R. E. GINNA NUCLEAR POWER PLANT

AMENDMENT TO PROVISIONAL OPERATING LICENSE

Amendment No. 40  
License No. DPR-18

ATTACHMENT TO LICENSE AMENDMENT NO. 40

FIGURE 3.10-1  
CONTROL ROD INSERTION LIMITS VERSUS CORE POWER  
FOR BOL THROUGH EOL

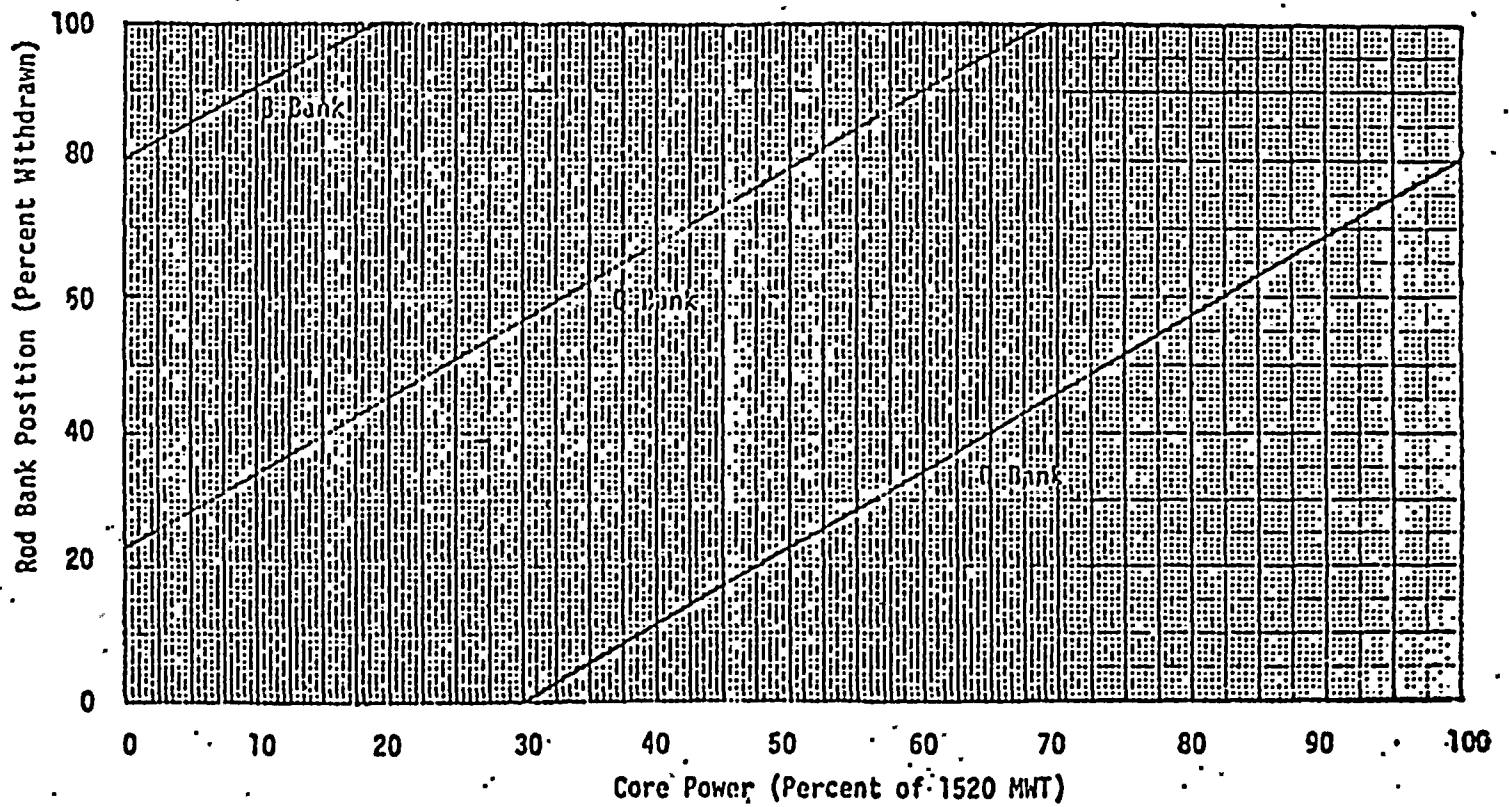
The lines shown on Figure 3.10-1 meet the shutdown requirement. The maximum shutdown margin requirement occurs at end-of-cycle life and is based on the value used in analysis of the hypothetical steam break accident. Early in cycle life, less shutdown margin is required, and Figure 3.10-2 shows the shutdown margin equivalent to that which is required at end-of-life with respect to an uncontrolled cooldown. All other accident analyses are based on 1% reactivity shutdown margin.

Figure 3.10-3 Normalized Axial Dependence Factor for  $F_Q$  versus Elevation

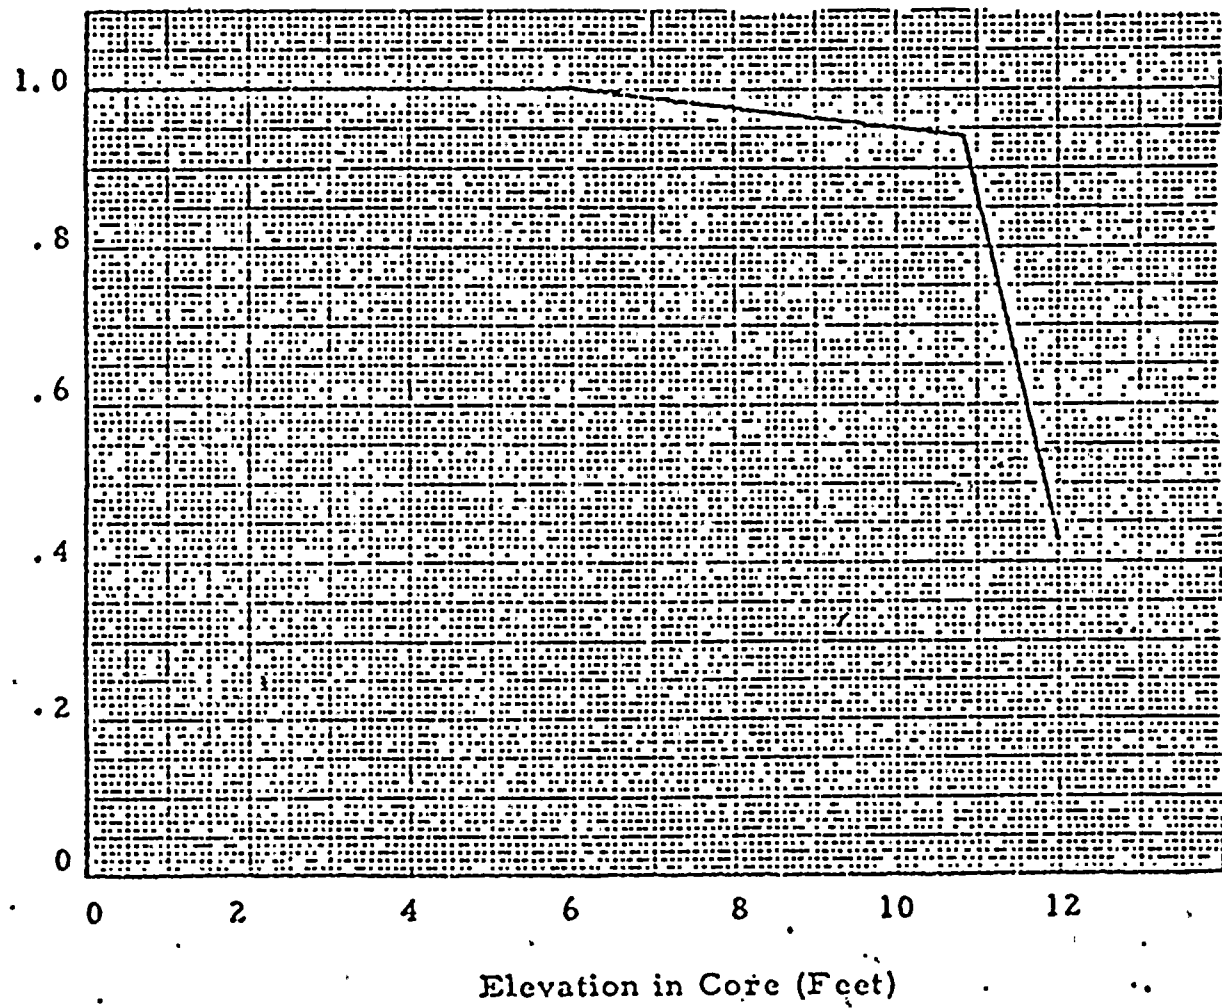
where P is the fraction of rated power at which the core is operating, K(Z) is the function given by Figure 3.10-3, and Z is the height in the core. The measured  $F_Q^N$  shall be increased by three percent to yield  $F_Q$ . If the measured  $F_Q$  or  $F_{\Delta H}^N$  exceeds the limiting value, with due allowance for measurement error, the maximum allowable reactor power level and the Nuclear Overpower Trip set point shall be reduced one percent for each percent which  $F_{\Delta H}^N$  or  $F_Q$  exceeds the limiting value, whichever is more restrictive. If the hot channel factors cannot be reduced below the limiting values within one day, the Overpower  $\Delta T$  trip setpoint and the Overtemperature  $\Delta T$  trip setpoint shall be similarly reduced.

An upper bound envelope of 2.32 times the normalized peaking factor axial dependence of Figure 3.10-3 has been determined from extensive analyses considering operating maneuvers consistent with the Technical Specifications on power distribution control as given in Section 3.10. The results of the loss of coolant accident analyses based on this upper bound envelope demonstrate compliance with the Final Acceptance Criteria limit for Emergency Core Cooling Systems.
